591, 593 COBBITTY ROAD &
1 FRESHWATER DRIVE, COBBITTY
(PRECINCT 2A STAGE 1 &
TRANCHE 5a STAGE 1)
ROAD & DRAINAGE DESIGN

ISSUED FOR SUBDIVISION WORKS CERTIFICATE

WORKS AS EXECUTED
WORKS AS EXECUTED INFORMATION SHOWN IN RED.
DATE: 15/09/2025

LINE O2H

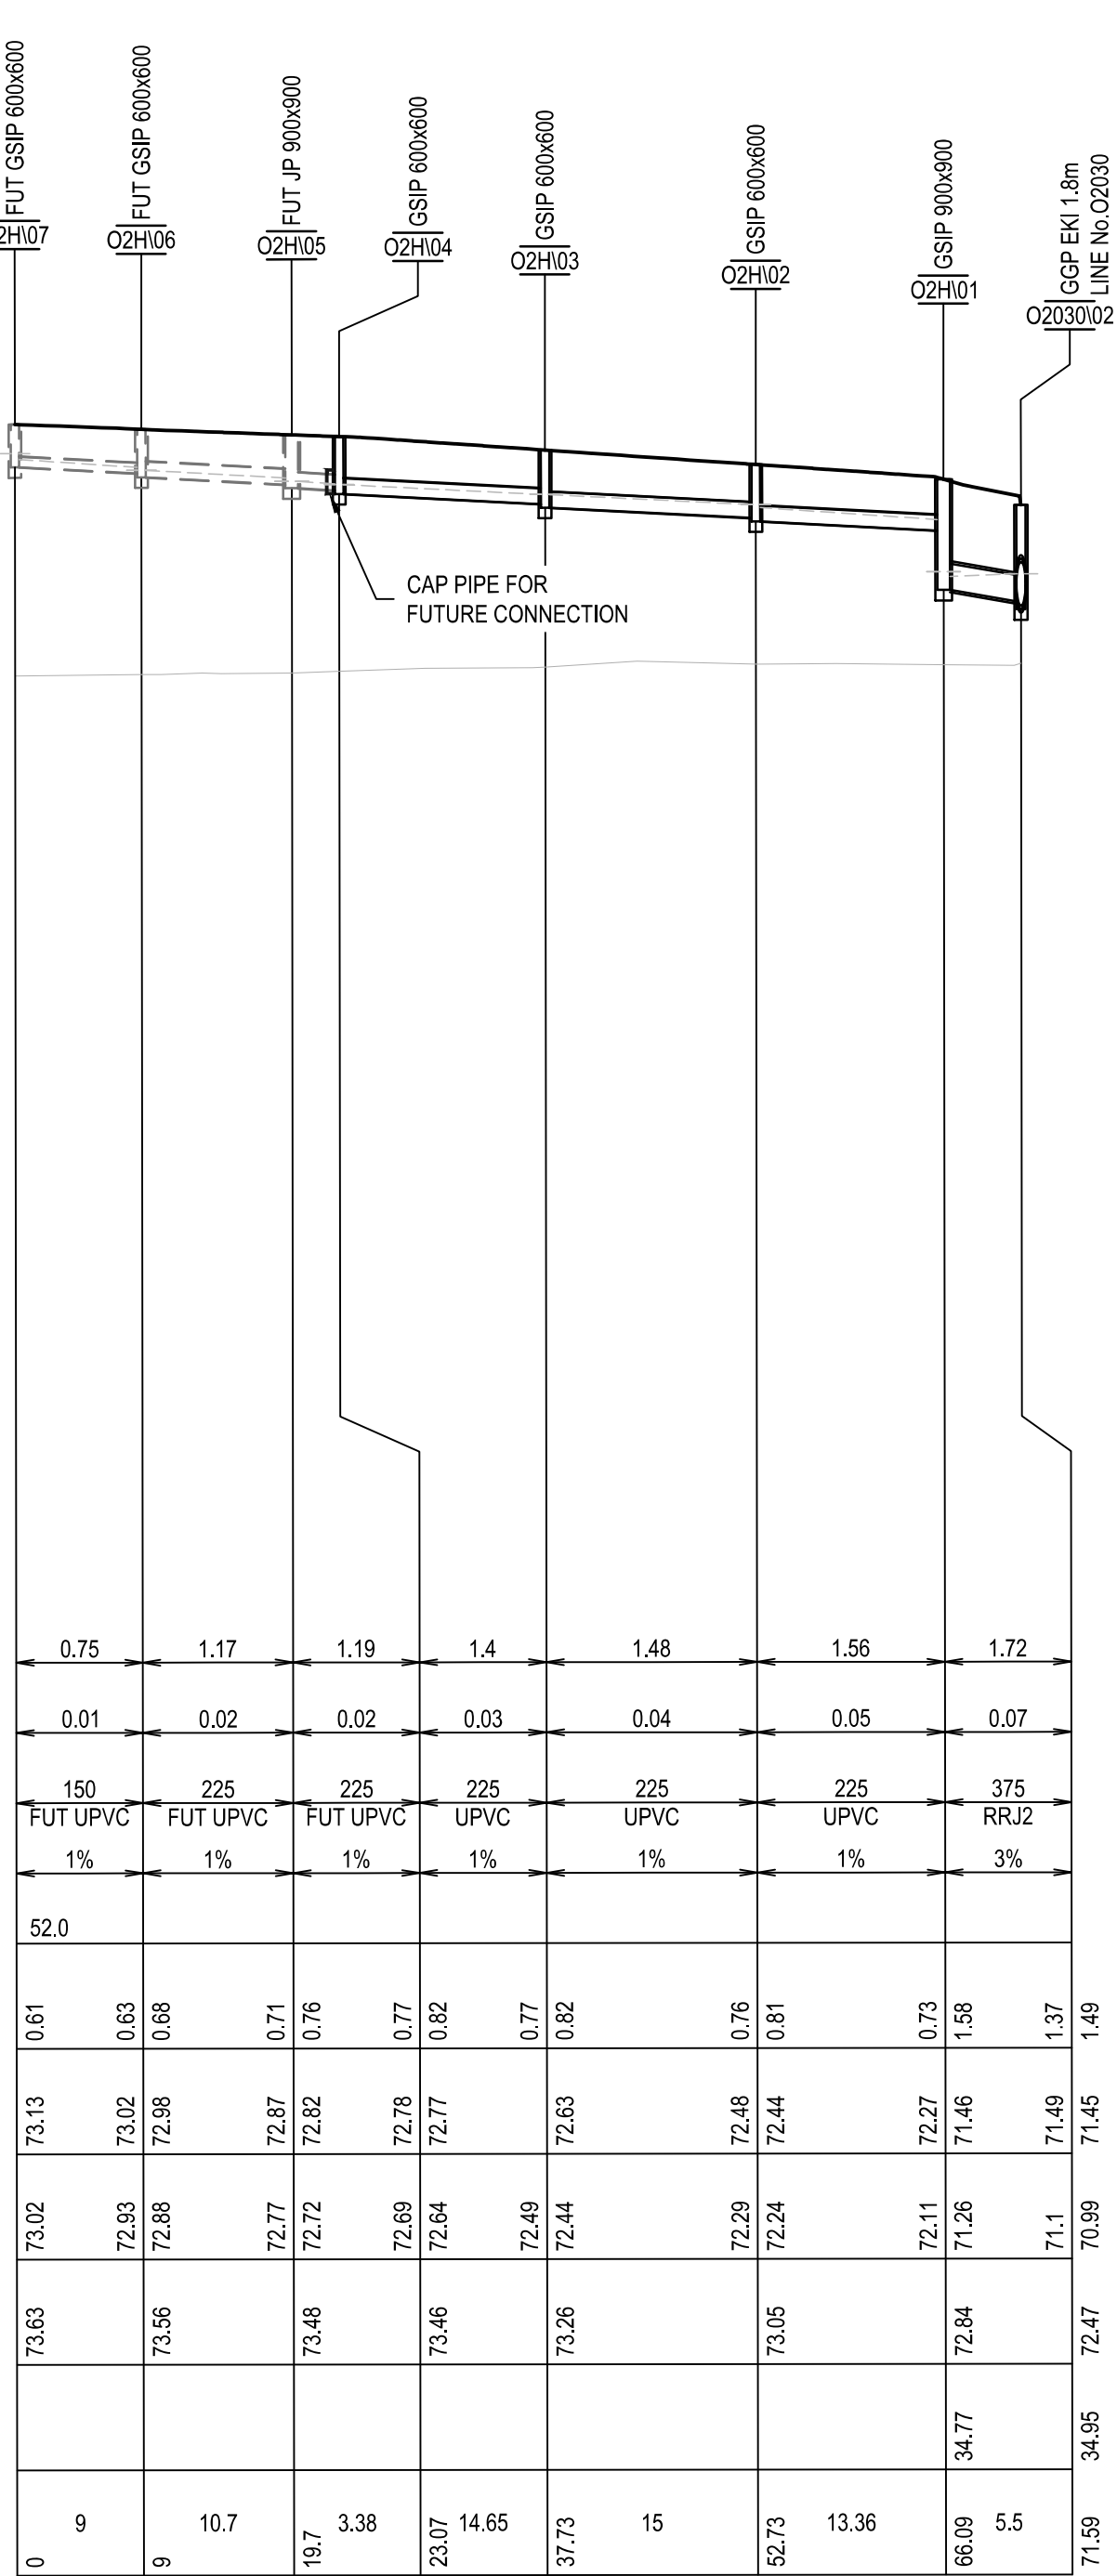
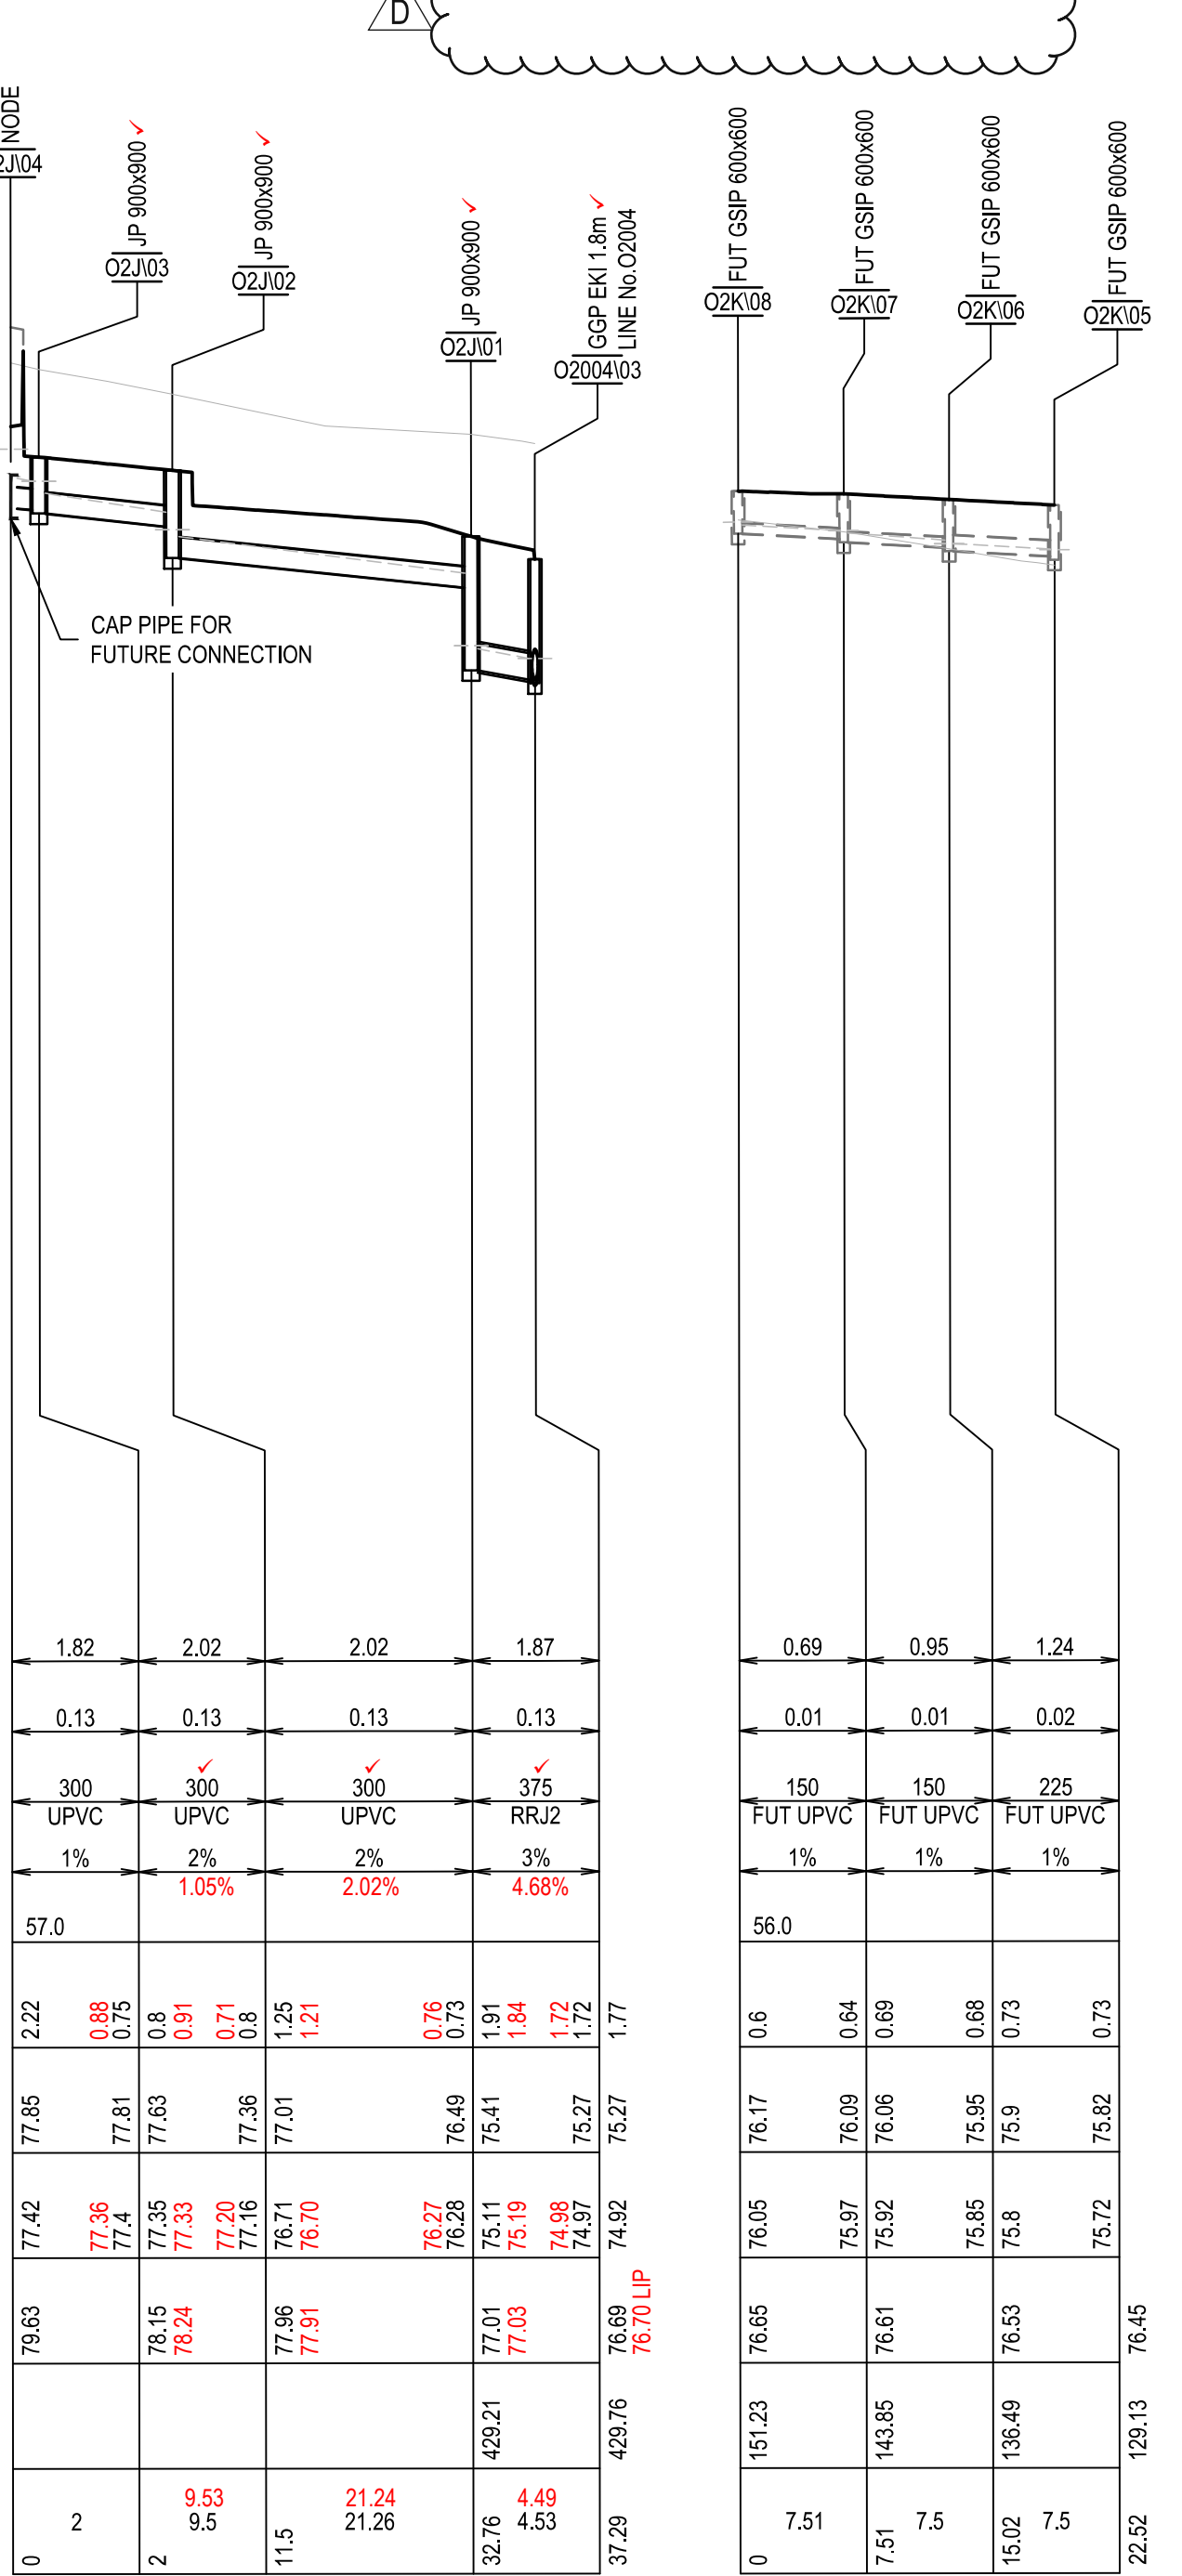
*PIPE O2000 UPSIZED
*PIT NUMBERS AMENDED
*HGL LOWERED

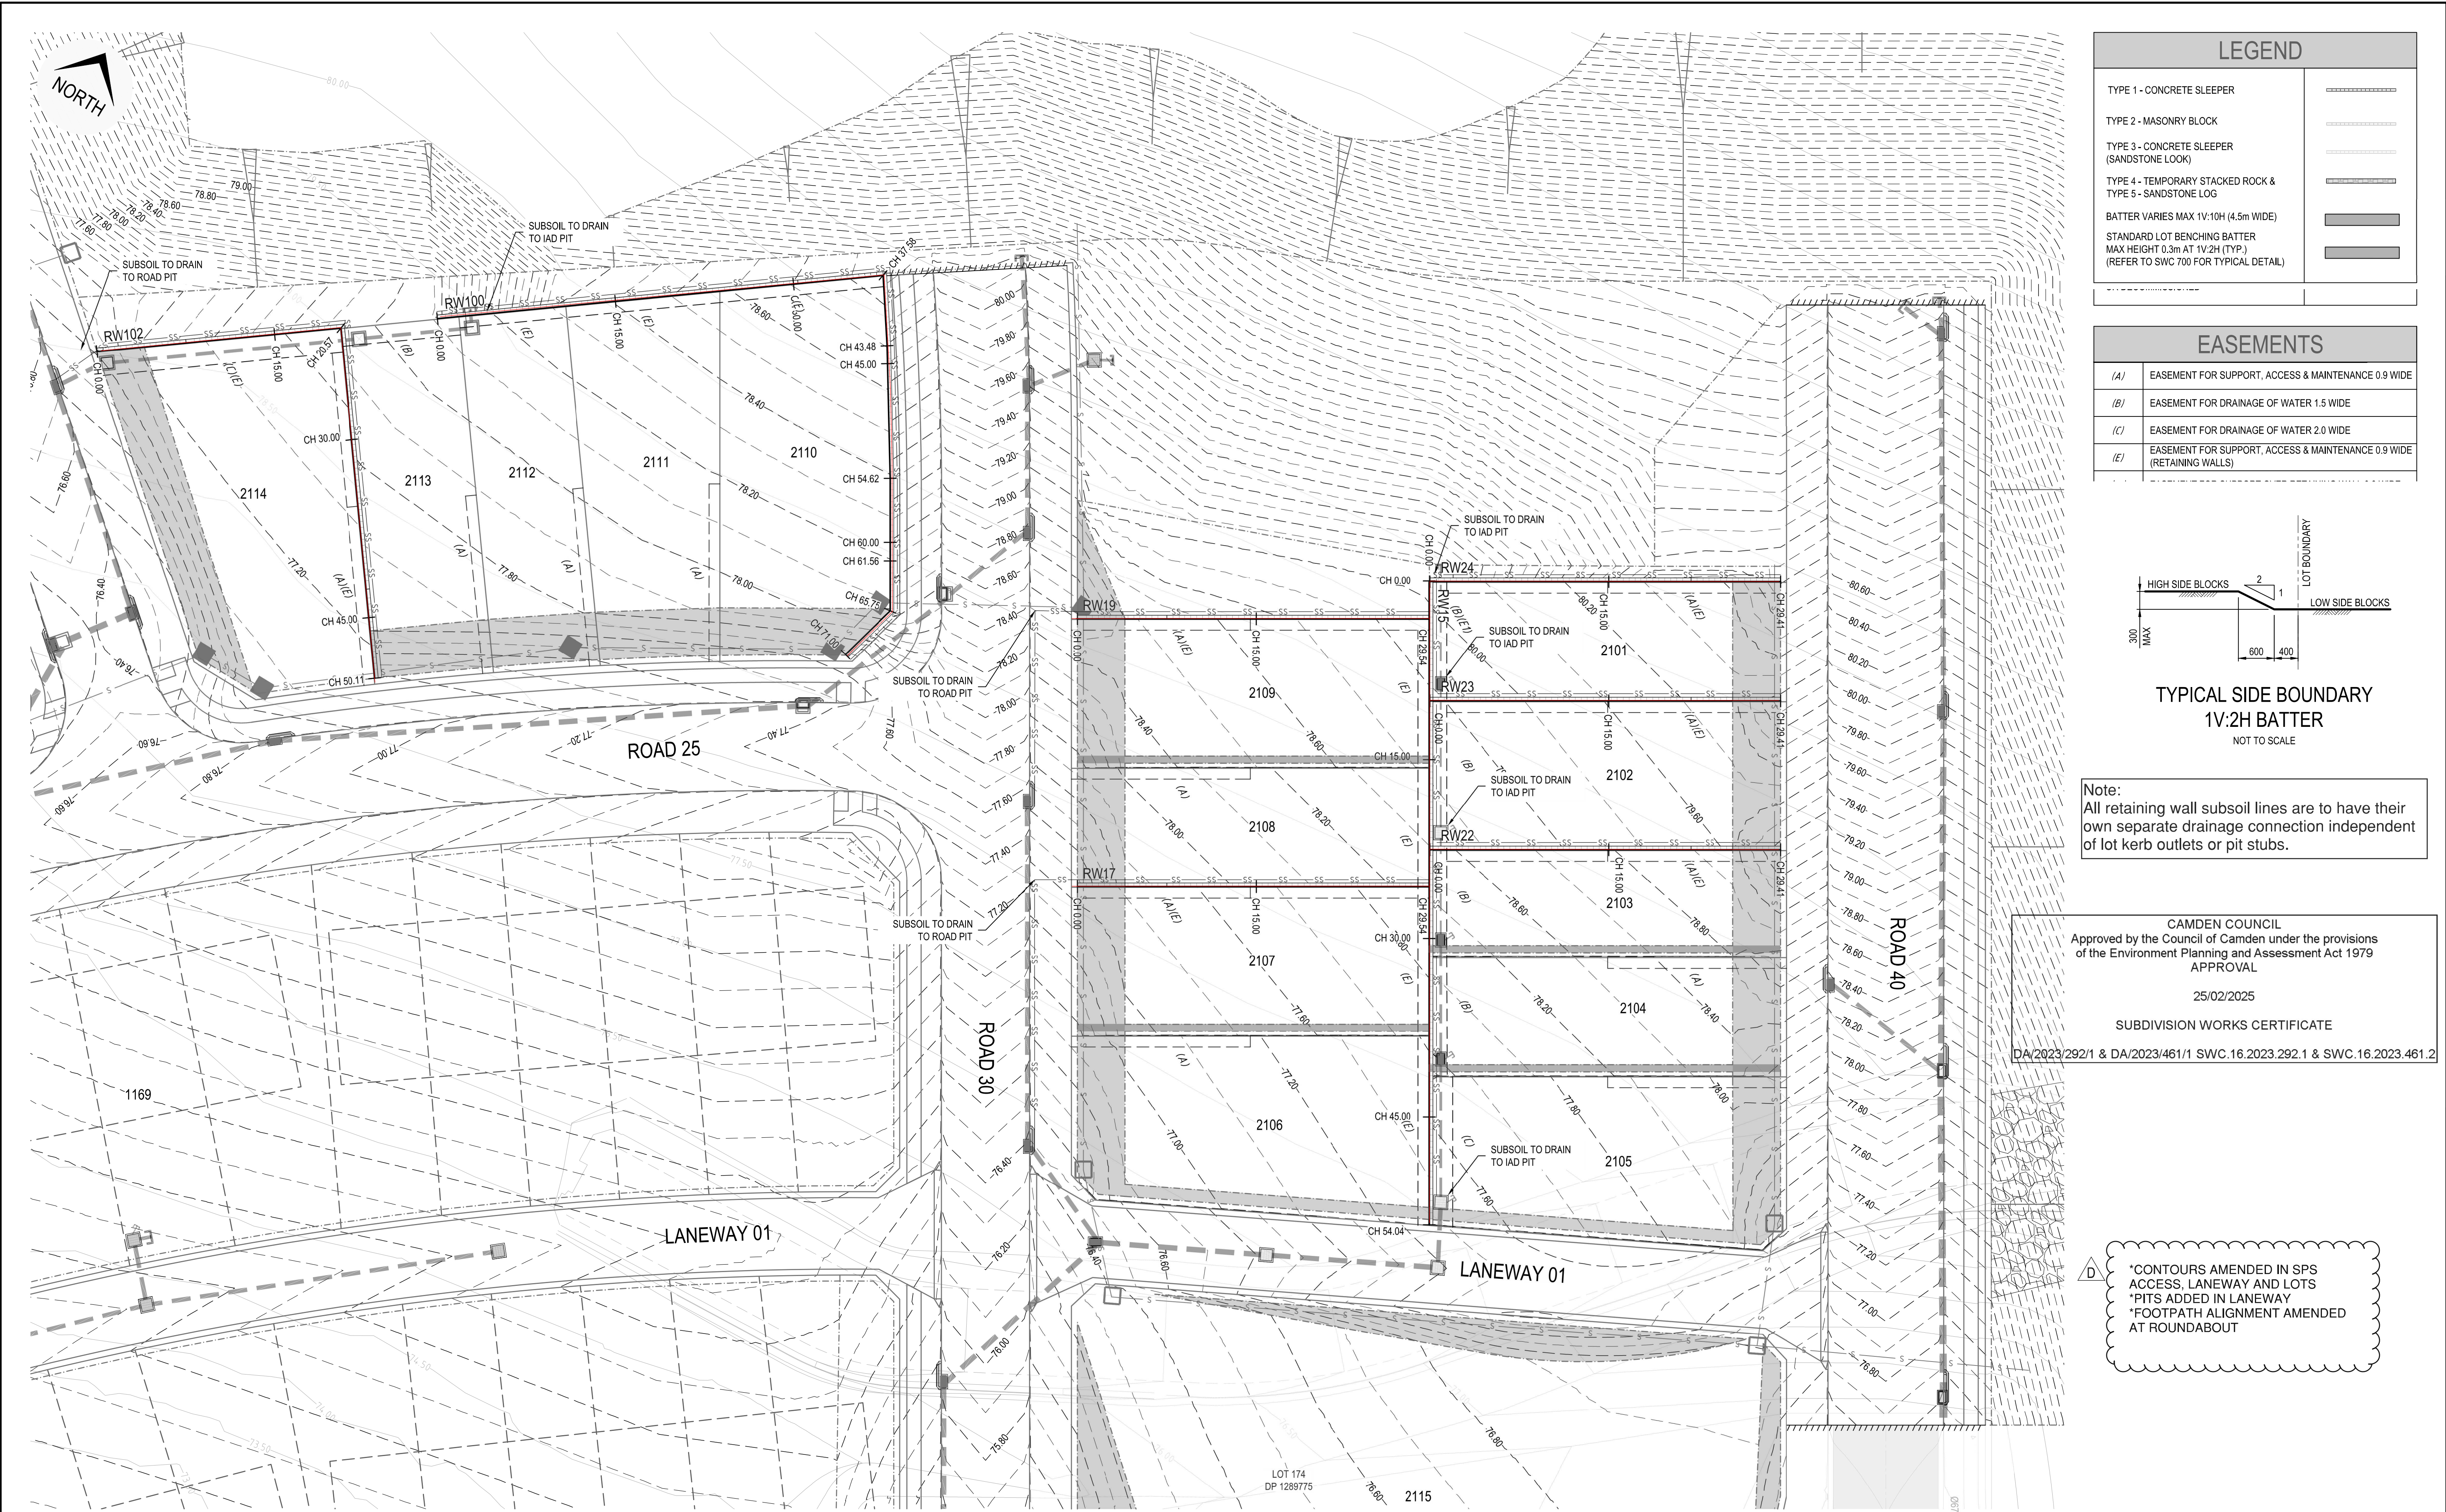
* CONTOURS AMENDED IN SPS ACCESS, LANEWAY AND LOTS
* PITS ADDED IN LANEWAY
* FOOTPATH ALIGNMENT AMENDED AT ROUNDABOUT
